OUR REF: JOB NO. 22203 – S4.55(8)

**RE: SECTION 4.55(8) MODIFICATION FOR DEVELOPMENT APPLICATION (DA-285/2023)  
NO. 1-7 ANDREWS AVENUE AND 26 GLEN STREET, BONDI**

This Section 4.55(8) Modification has been prepared for Andrews AV Pty Ltd by George Karavanas Planning Pty Ltd – (hereafter referred to as GSA Planning). On behalf of the applicant, we hereby seek approval for a Section 4.55(8) modification of the approved (DA No. 285-2023) at No. 1-7 Andrews Avenue and 26 Glen Street, Bondi ('the subject site').

**Figure 3: Approved and Proposed Basement Floor Plan**

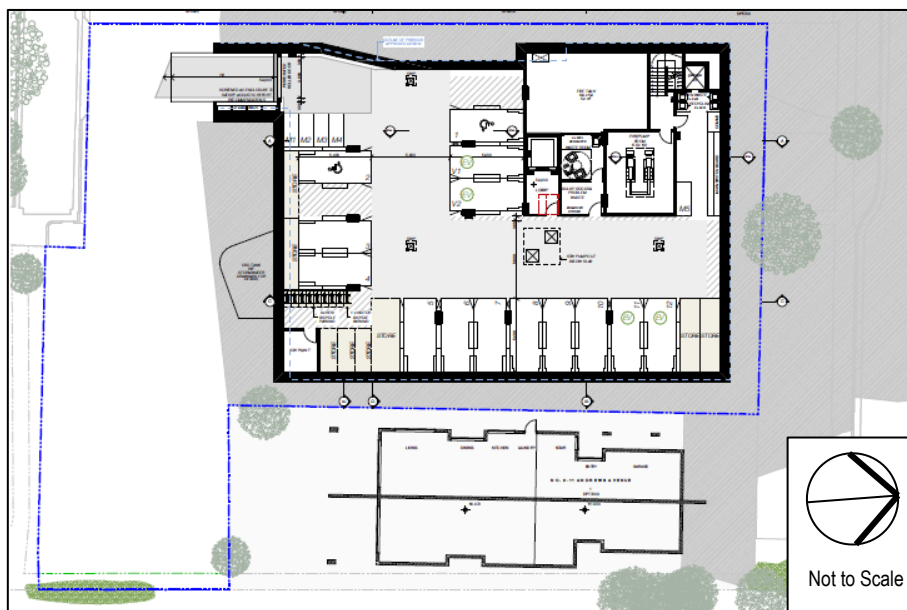
The Basement Floor Level is at RL 59.30 (as approved). The modifications at this level include:

- Adjustment to basement shoring to reflect traffic engineering advice regarding access
- Alterations to the car, bicycle and motorcycle parking provision to align with the modified apartment mix
- Adjustments to basement services to reflect services spatial advice and inclusion of a fire tank
- Minor change to the position of the southern wall to accommodate storage as required by DA conditions of consent
- Slight increase to shoring wall thickness in accordance with structural engineering advice (see Figure 3).

**Figure 5: Approved and Proposed Level 01 Plan**

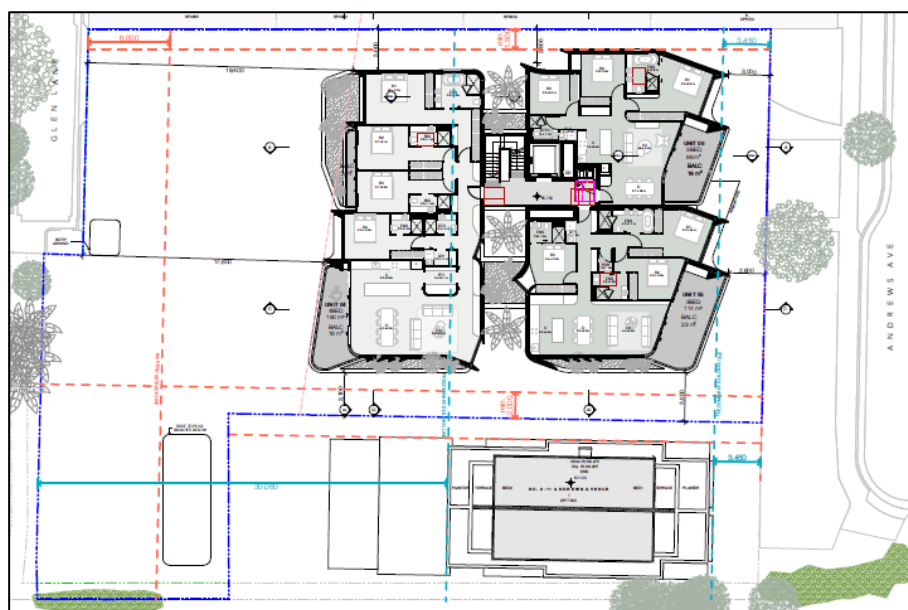
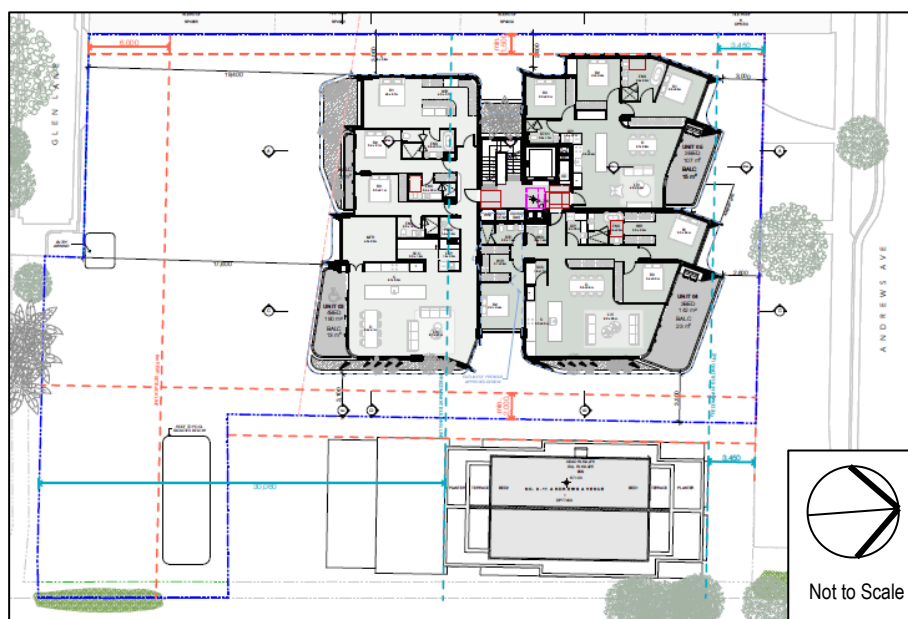
Level 01 is at RL 65.700 and contains 3 x 3-bedroom units. The modifications at this level include:

- Minor increases to internal footprint, all within the approved external building envelope
- General internal layout changes as coordinated with the interior architect
- Bin storage relocated and service risers coordinated as per services advice
- Western planter altered to align with ground floor adjustment
- Planter extent increased in accordance with the DA conditions of consent
- Structural blades added to the eastern planters in accordance with structural engineer's advice (see **Figure 5**).

**Figure 6: Approved and Proposed Level 02 Floor Plan**

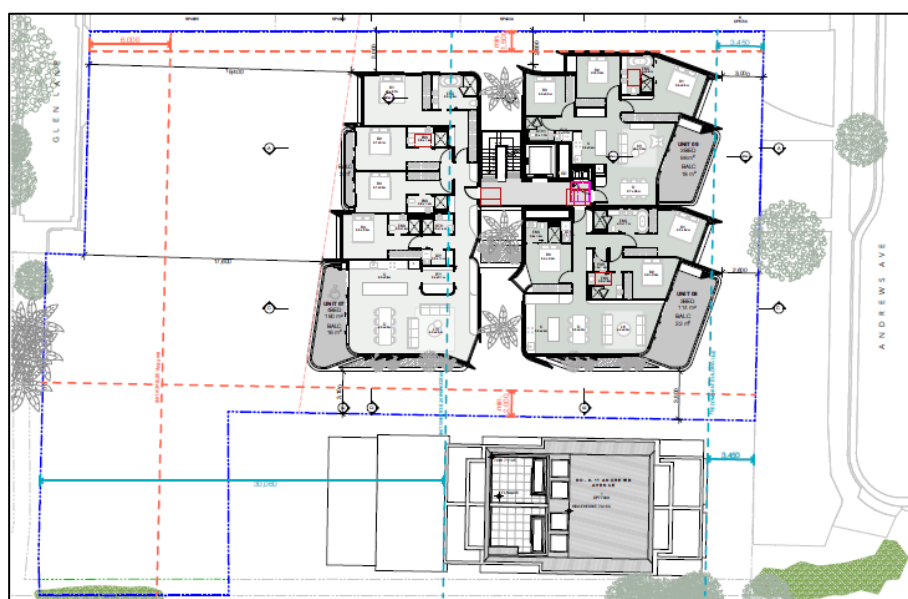
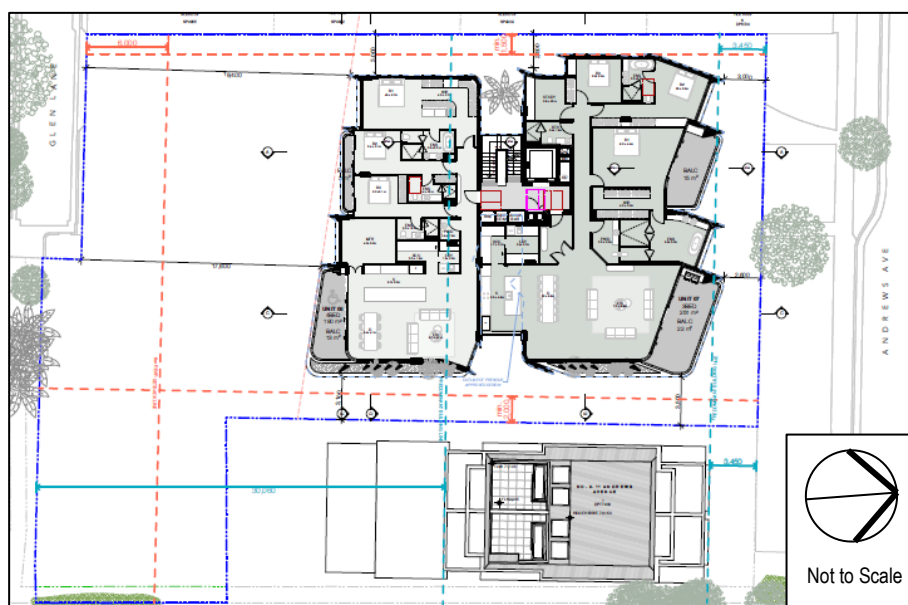
Level 02 is at RL 68.800 (as approved). The approved level contained 2 x 3-bedroom units and 1 x 4-bedroom unit, which this application changes to 2 x 3-bedroom units. The other modifications at this level include:

- Minor increases to internal footprint, all within the approved external building envelope
- General internal layout changes as coordinated with the interior architect
- Bin storage relocated and service risers coordinated as per services advice
- Western planter altered to align with ground floor adjustment
- Planter extent increased in accordance with the DA conditions of consent
- Structural blades added to the eastern planters in accordance with structural engineer's advice (see **Figure 6**).

**Figure 7: Approved and Proposed Level 03 Floor Plan**

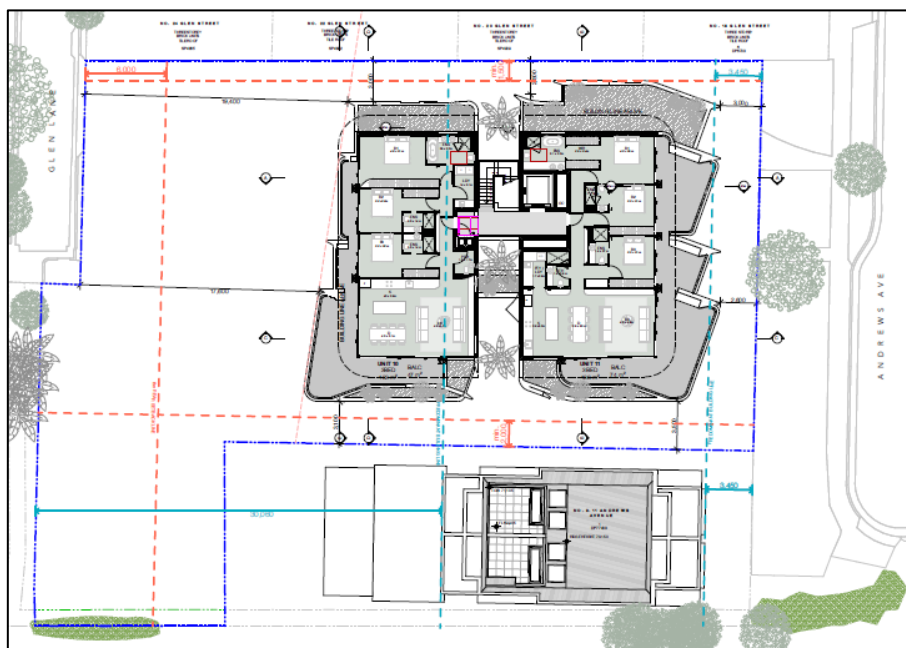
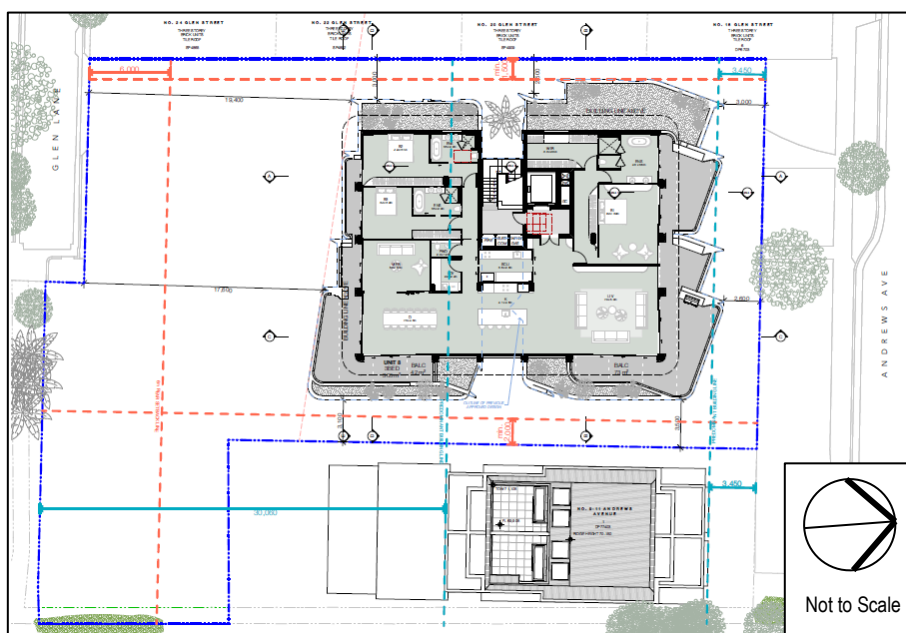
The Level 03 is at RL 71.900 (as approved). The approved level contained 2 x 3-bedroom units, which this application changes to 1 x 3-bedroom unit. The other modifications at this level include:

- Increase to internal footprint, within the approved external building envelope
- General internal layout changes as coordinated with the interior architect
- Bin storage relocated and service risers coordinated as per services advice
- Planter extent increased in accordance with the DA conditions of consent (see **Figure 7**).

**Figure 9: Approved and Proposed GFA Calculation Diagrams**

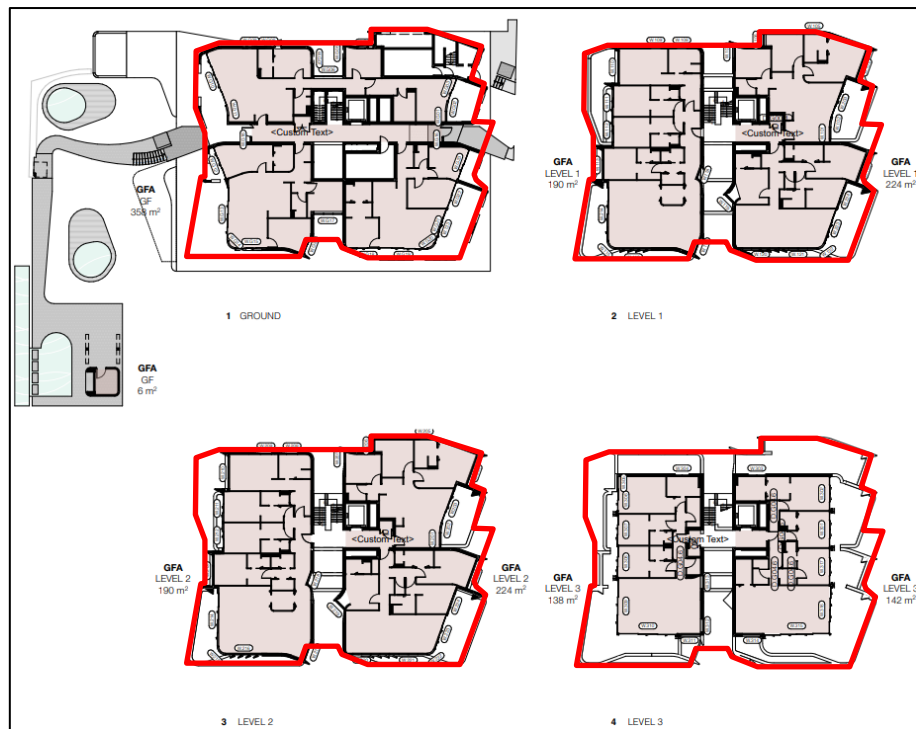
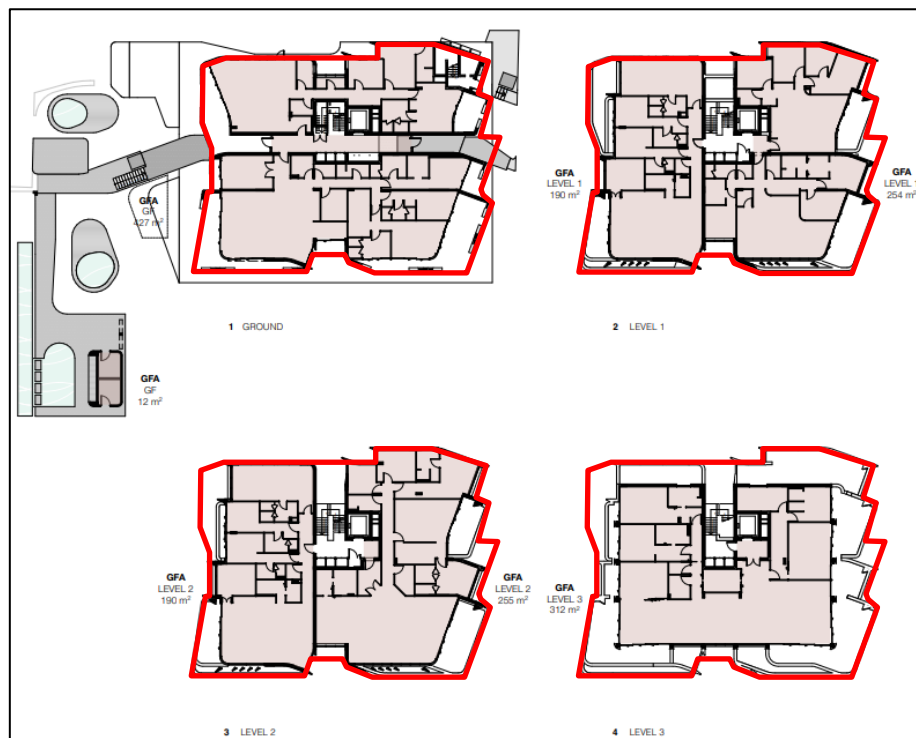
Council's LEP prescribes a maximum FSR of 0.9:1 and Gross Floor Area (GFA) of 1,471.824m<sup>2</sup>. The approved development has a GFA of 1,471.7m<sup>2</sup> and FSR of 0.9:1. The modifications proposed in this application will increase the GFA to 1,640.5m<sup>2</sup> and FSR to 1:1. This varies from the development standard by 168.676m<sup>2</sup> or 11.46%.

The additional GFA is located within the external envelope of the approved development (or at the rear of the property adjacent to the approved communal amenities). The GFA is largely attributed to adjustments to wall and glazing lines within the approved balconies and cut-outs. These do not extend any closer to the boundaries than what was approved in the DA. In other words, despite the numerical increase in GFA, the visual bulk and scale of the development is the same as the approval, because the approved setbacks, external envelope and height are maintained (see **Figure 9**).
